DIMENSIONAL LAYOUT
SCALE=1"=50'

GRADING & DRAINAGE PLAN
SCALE=1"=50'

**AS BUILT
DRAWING**

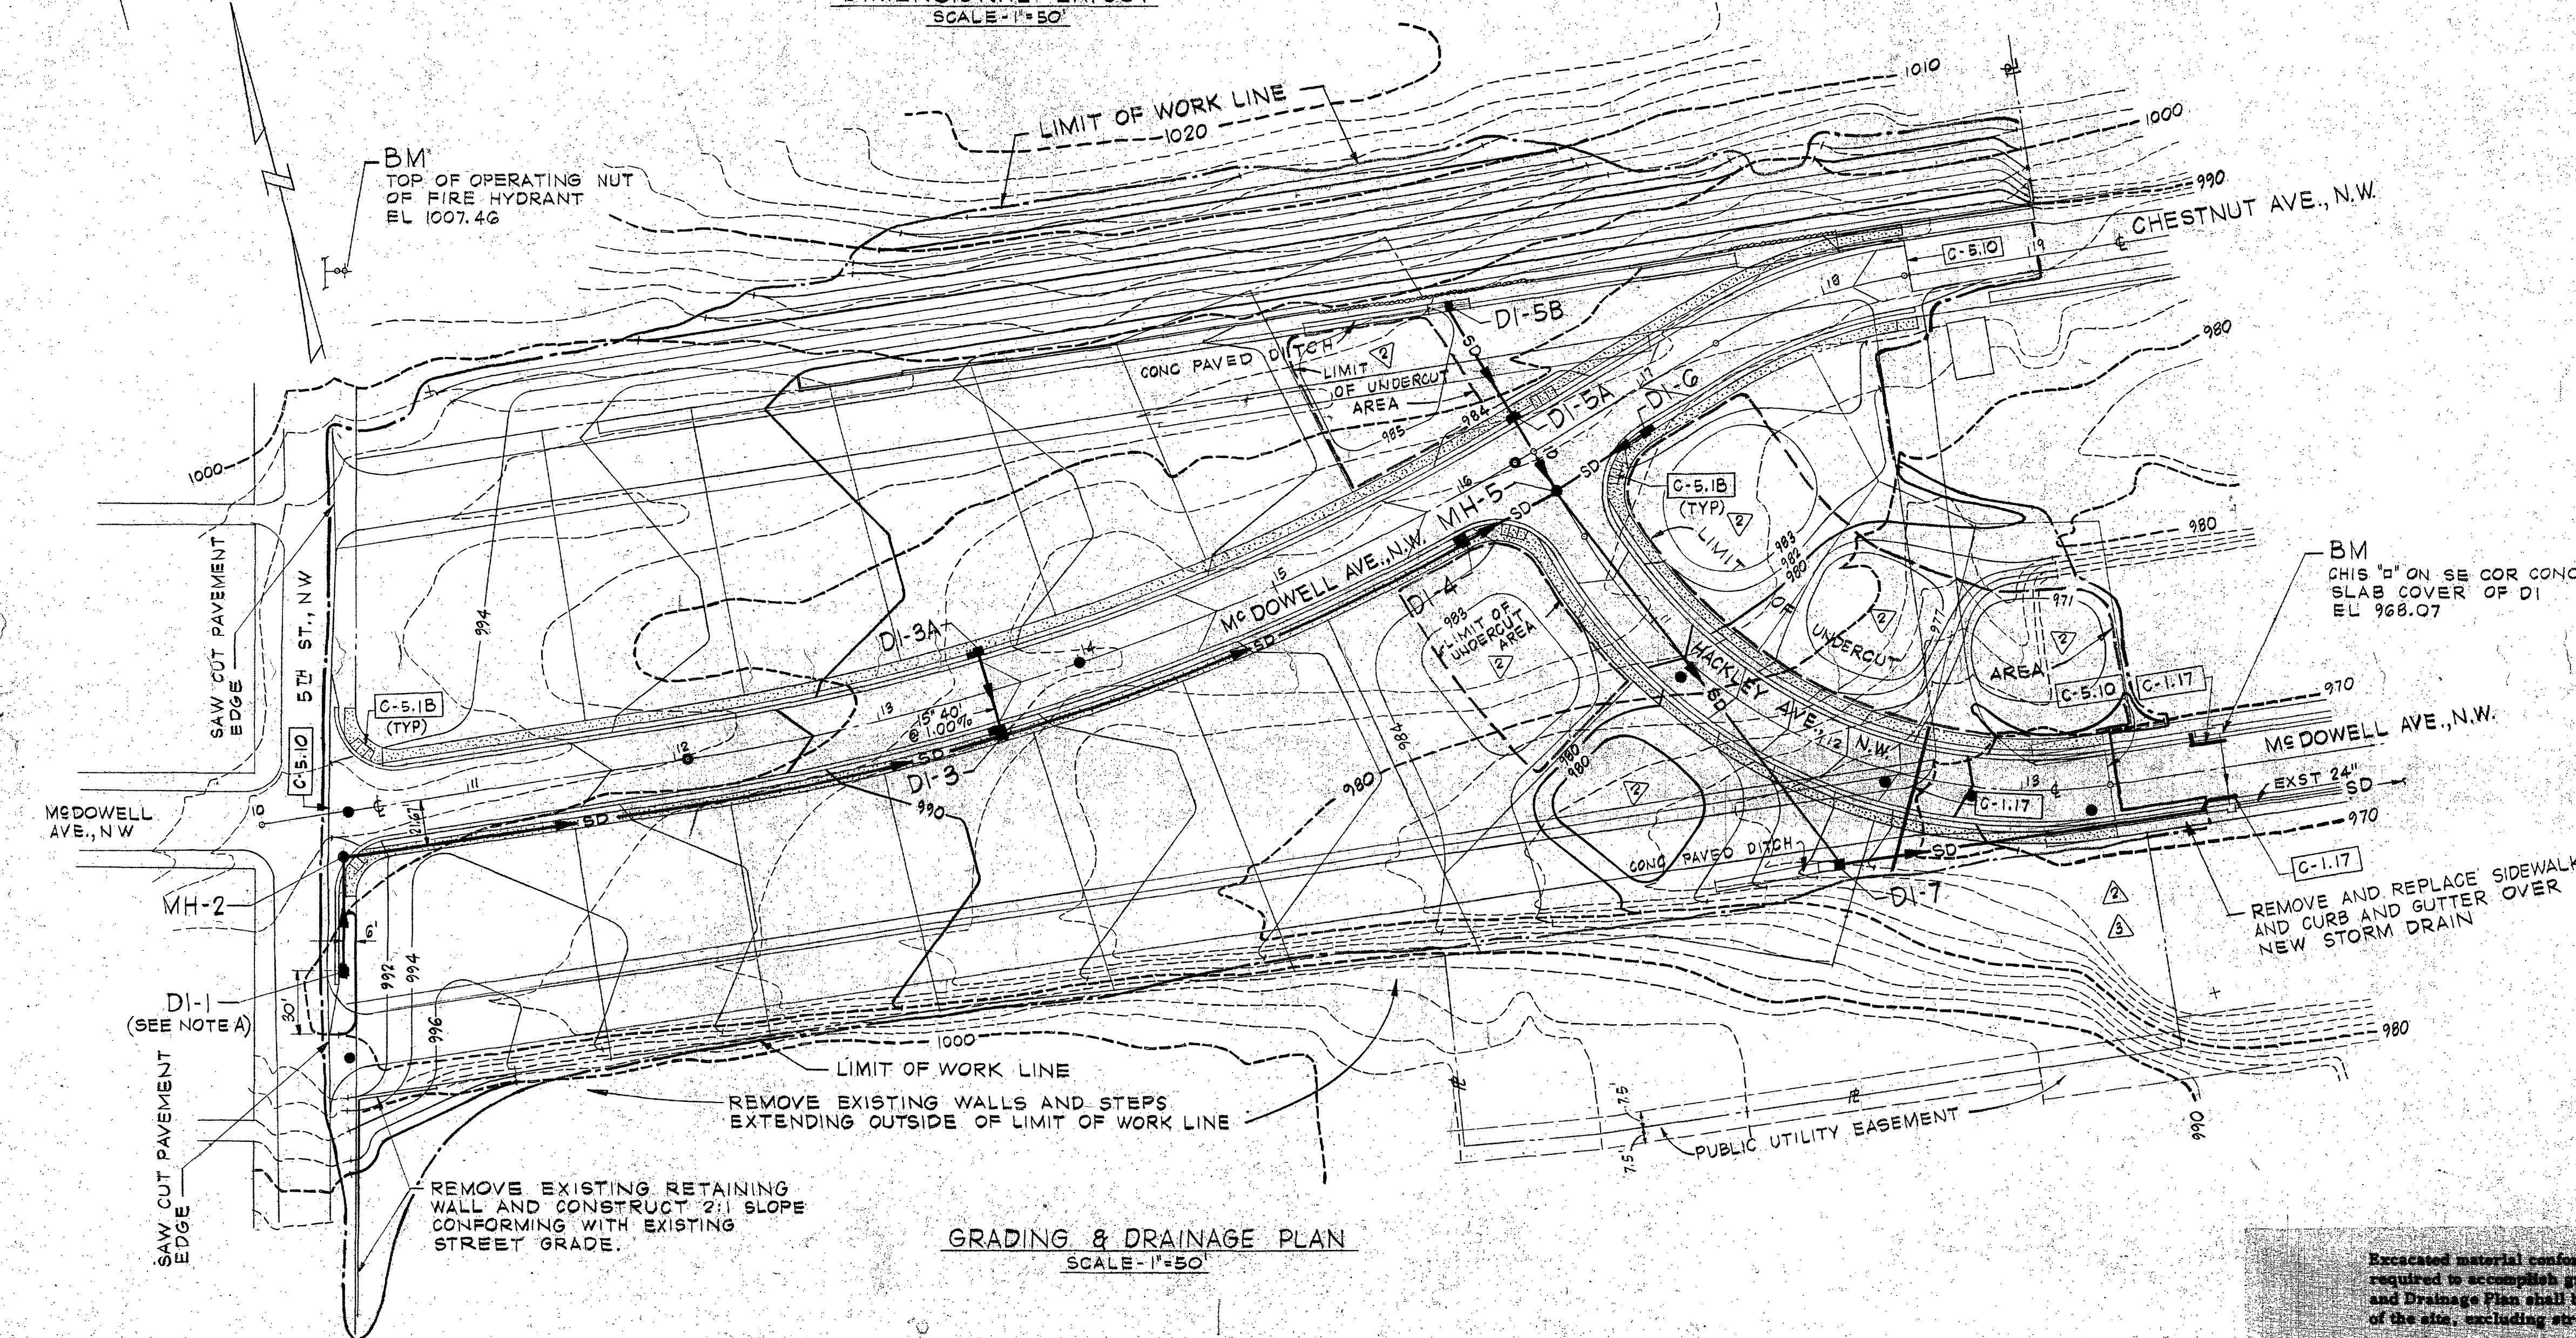
10-15-79	AS BUILT	JHW
12-8-78	RELOCATED DRIVEWAY ENTRANCES	JHW
11-22-78	REMOVED FINISHED GRADE CONTOURS, RETAINING WALL & CONC ENTRANCE TO LOT 9, BLOCK 2. ADDED AREAS TO BE UNDERCUT.	JHW
10-78	ADDITIONAL SITE GRADING BOTH SIDES OF HACKLEY AVE., ADDED 24" WIDE ENTRANCES & ADDED NEW CONC RETAINING WALL.	JHW
6-2-78	ADDED NEW STREET NAMES PER CITY OF ROKE PLANNING DEPT	JHW
REVISION	DATE	DESCRIPTION
DESIGNED	J.H.W.	
DRAWN	J.H.W.	
CHECKED	JHW	
APPROVED	JHW	
SUBMITTED	JHW	
SITE IMPROVEMENTS CONTRACT SI-3 SECTION FIVE GAINSBORO NEIGHBORHOOD DEVELOPMENT PROGRAM		
DIMENSIONAL LAYOUT, GRADING & DRAINAGE PLAN, TYPICAL STREET SECTION AND GENERAL NOTES		
HAYES, SEAY, MATTERN & MATTERN ARCHITECTS - ENGINEERS - PLANNERS ROANOKE, VIRGINIA RICHMOND, VIRGINIA VIRGINIA BEACH, VIRGINIA WASHINGTON, D.C.		SCALE AS NOTED COMM. NO. 3756C DATE 24 MAR 1978 SHEET 1

Excavated material conforming with the specifications for site fills and not required to accomplish grading in accordance with Revision 2 to Grading and Drainage Plan shall be uniformly spread and compacted on the remainder of the site, excluding streets, as directed by the Architect-Engineer.
